ADDENDUM 01

Project Title: **Blinn Mechanical Project – Brenham – Melcher + BCPA Phase 2**
RSE Project #: **1540**

This **ADDENDUM** shall modify, amend, extend and become a part of the Contract Documents dated 1/13/25 prepared by Ramirez Simon Engineering, LLC (RSE) in accordance with the terms therein, as if written out in full therein and bound originally therewith.

2 PLUMBING BCPA2 ENLARGED FLOOR PLAN
1/4" = 1'-0"

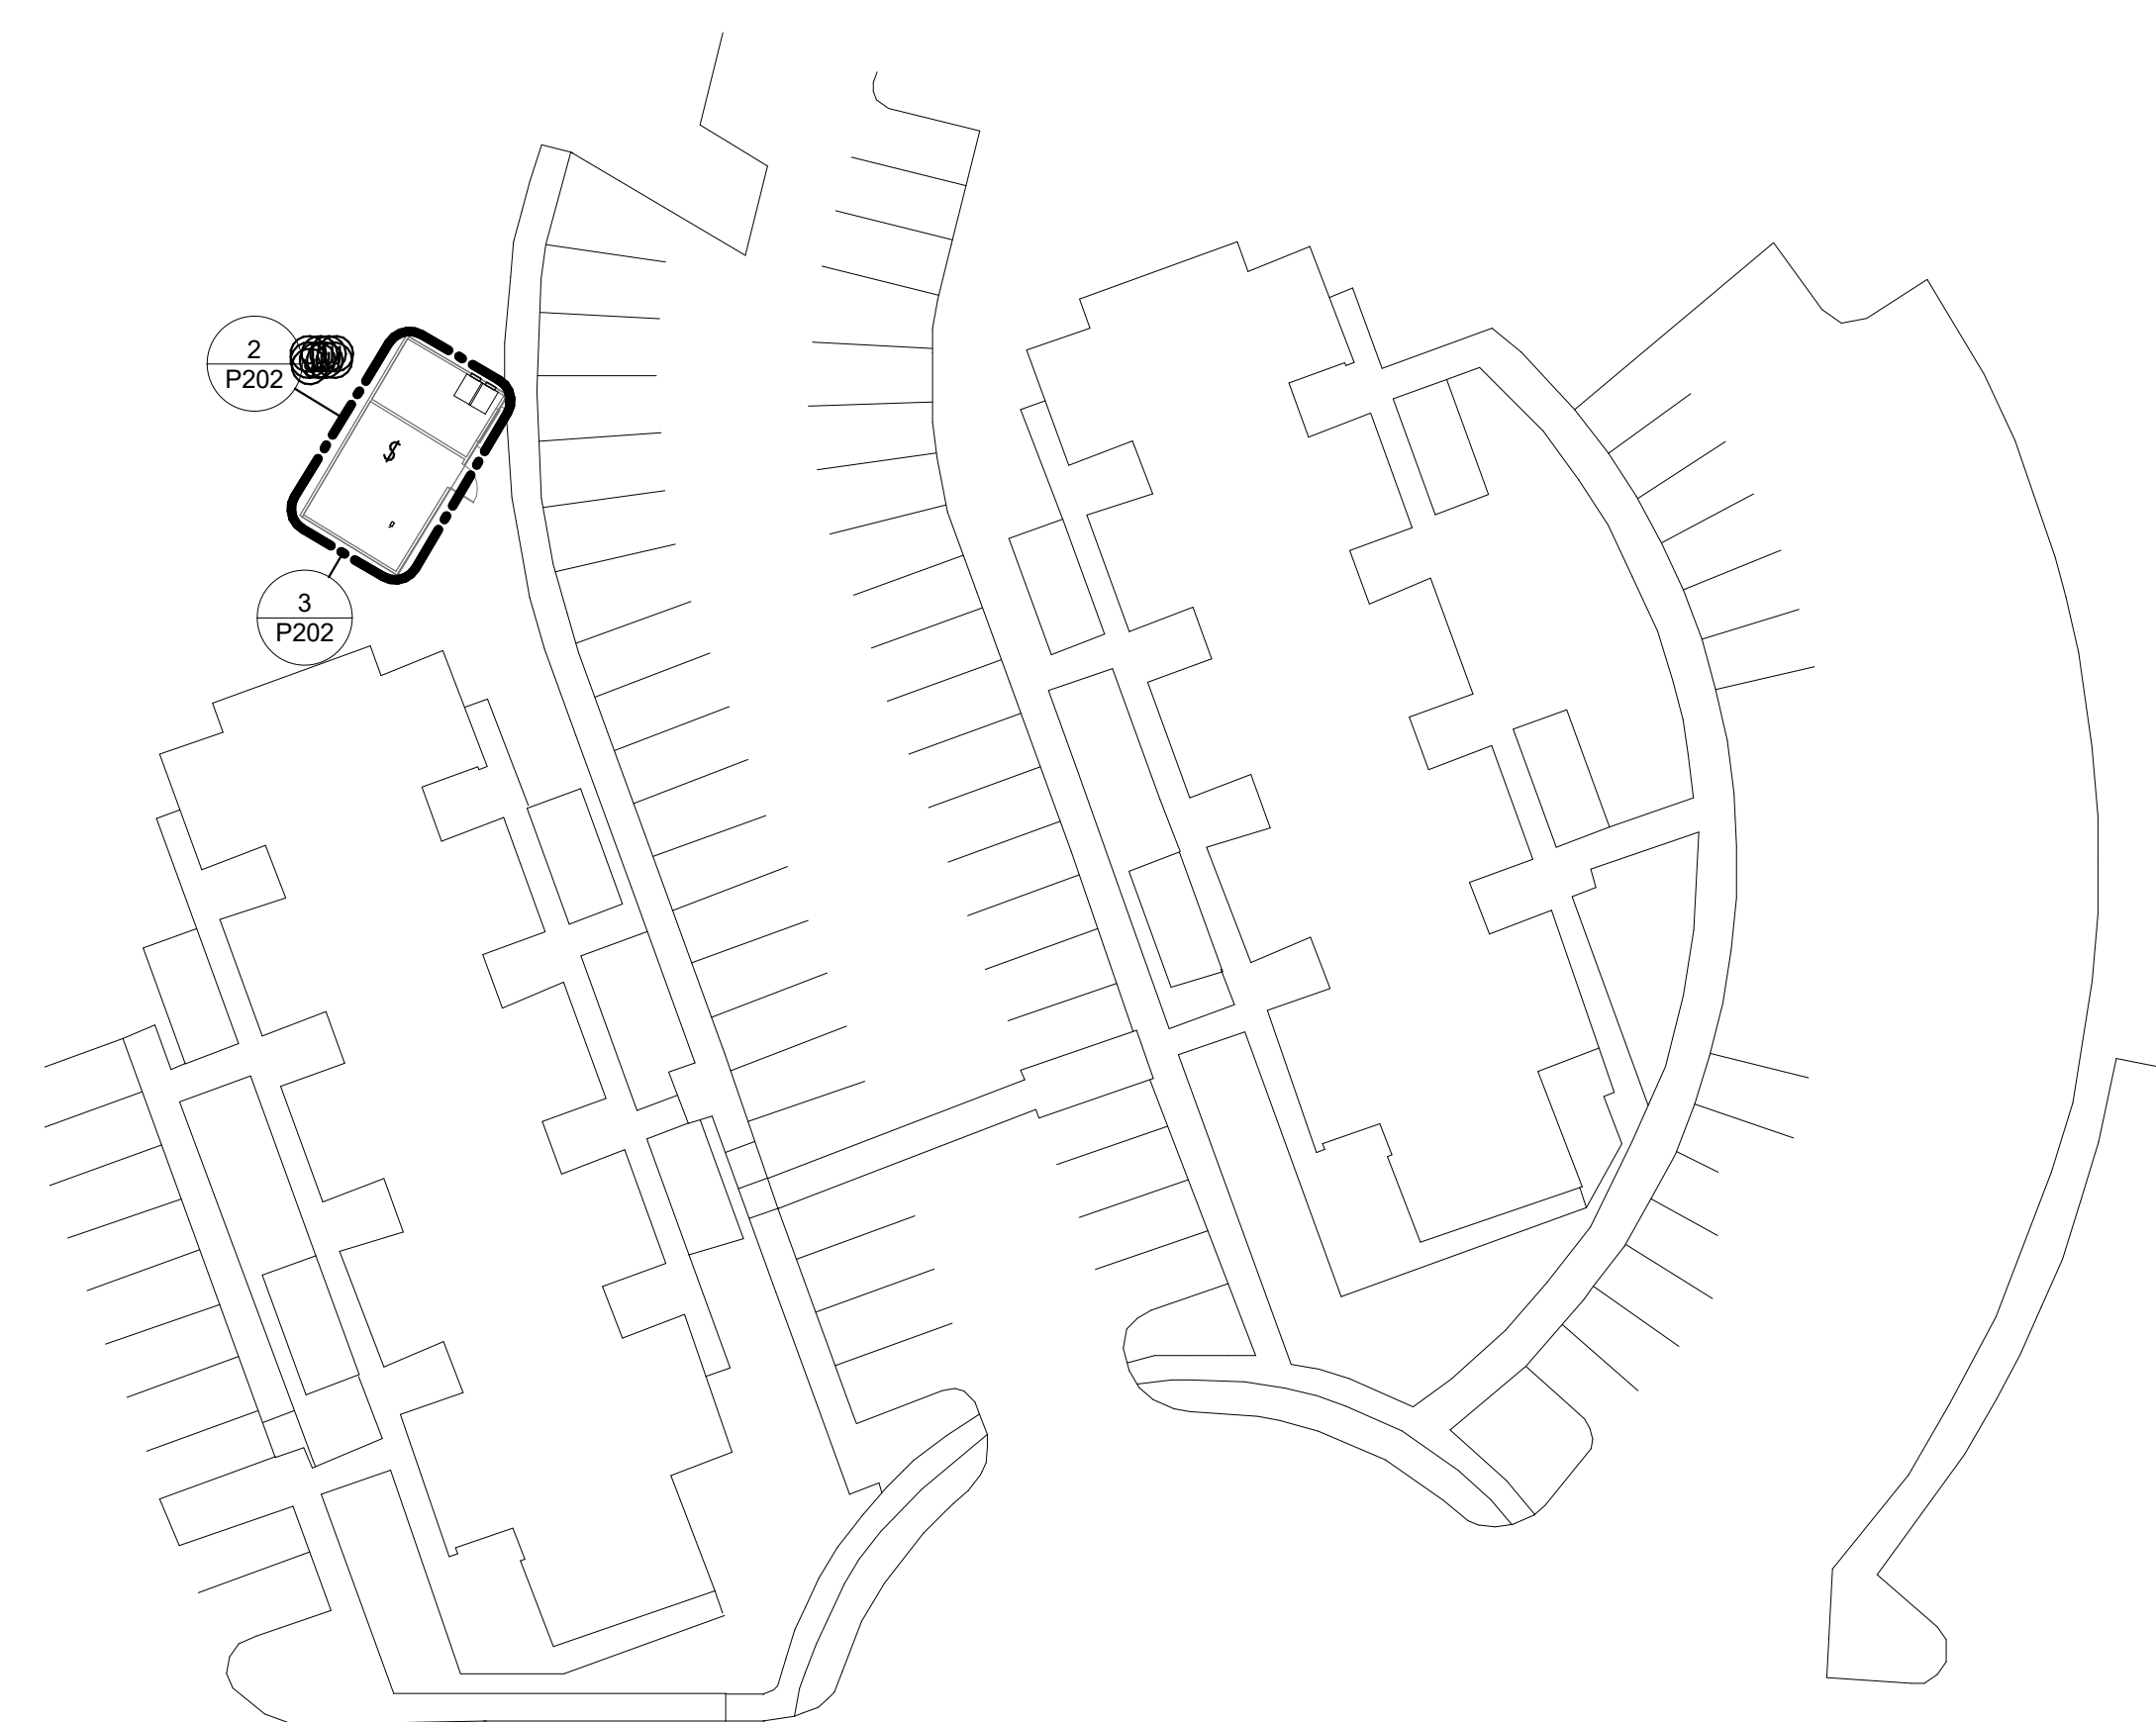
2. P202 – PLUMBING BCPA2 FLOOR PLAN
 - a. Updated number of tankless water heaters to 8 for base bid.
 - b. Added a alternate design to add a additional.
 - c. Updated piping on demo and new floor plans
 - d. Removed note referring to heat trace all pipes in area.
 - e. Added a note to remove insulation to softener.
 - f. Added note to demo existing expansion tank.
 - g. Added a note to remove existing flu back to roof penetration and abandon in place.
 - h. Added note to general note and to plans

① TANKLESS WATER HEATER RACK (10)
NO SCALE

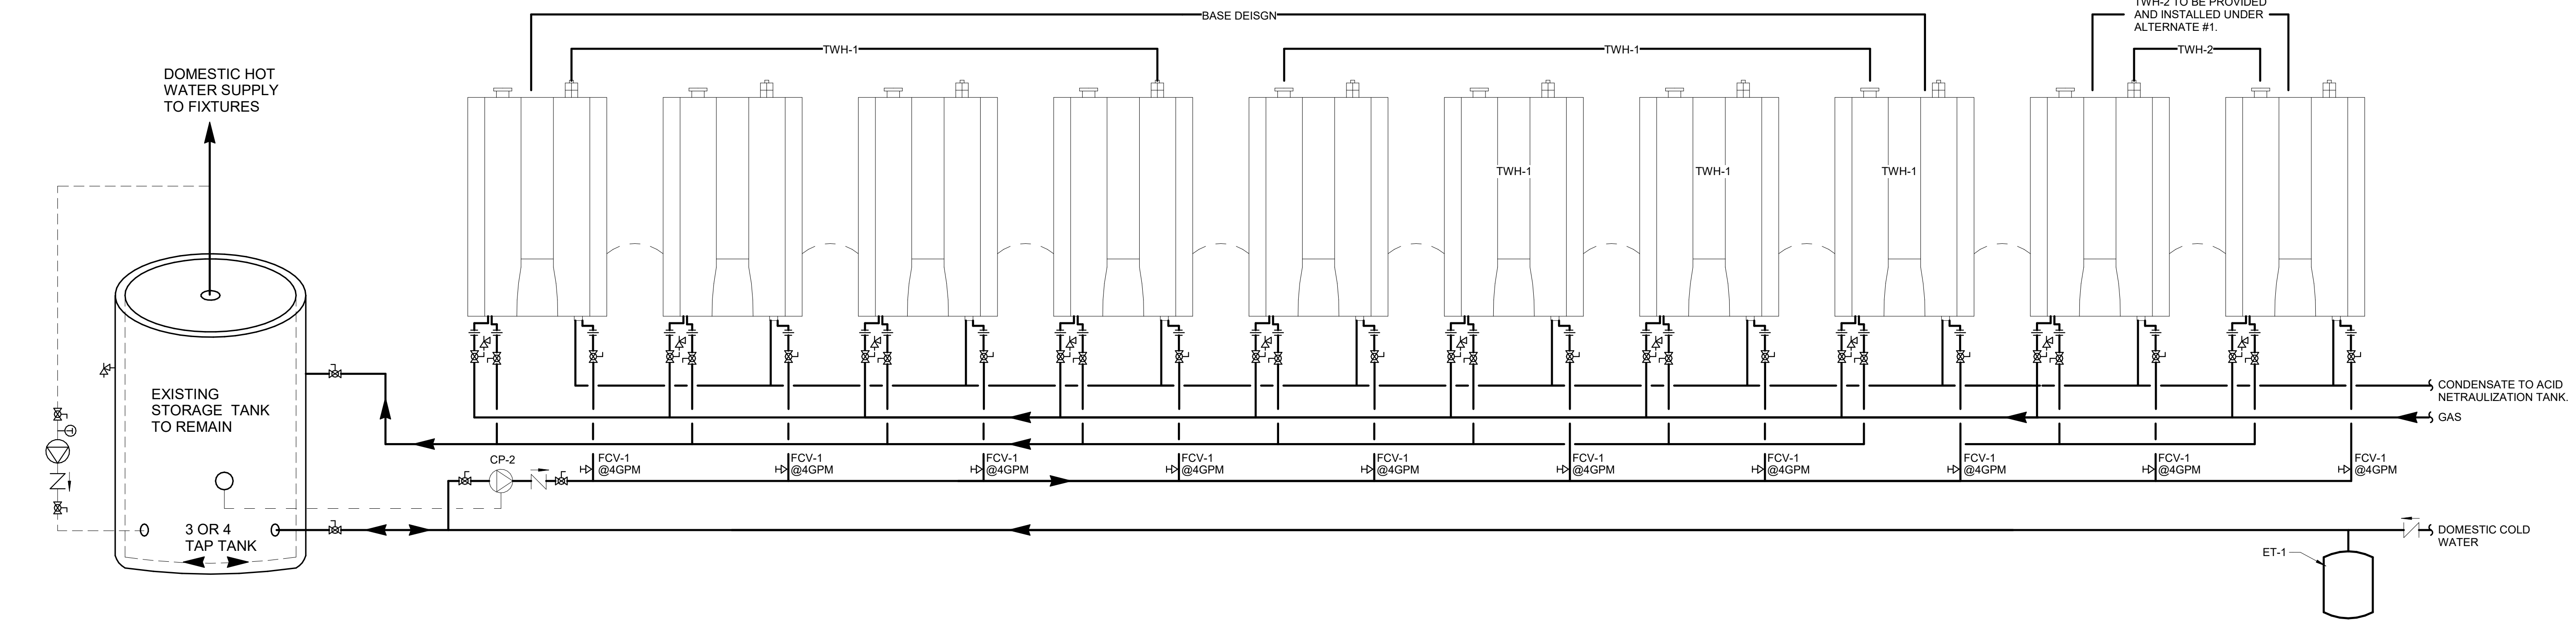
3. P501- PLUMBING DETAILS
 - a. Changed sheet name to PUMBING SCHEDULES & DETAILS
 - b. Updated Fixture schedule to show new expansion tank.
 - c. Updated Water heater schedule to reflect owner specific tankless manufacture.
 - d. Updated tags on Water heater Schedule to reflect new tagging changes.
 - e. Updated Pump schedule to reflect owner Specific manufacture for pumps.
 - f. Updated detail to show alternate #1
